3RD STORY WALL CHANGE:

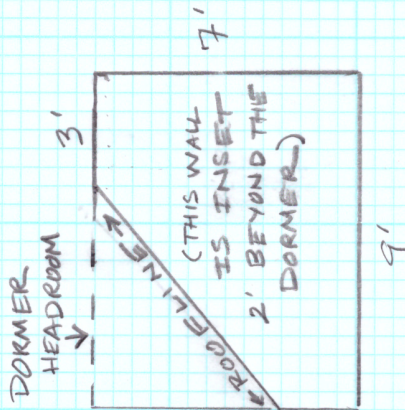
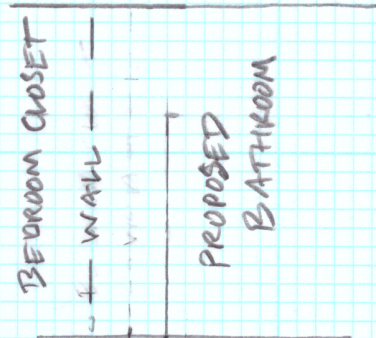
3RD FLOOR
SIDEWALL
SEPARATING
BR CLOSET
FROM
PROPOSED
BATH
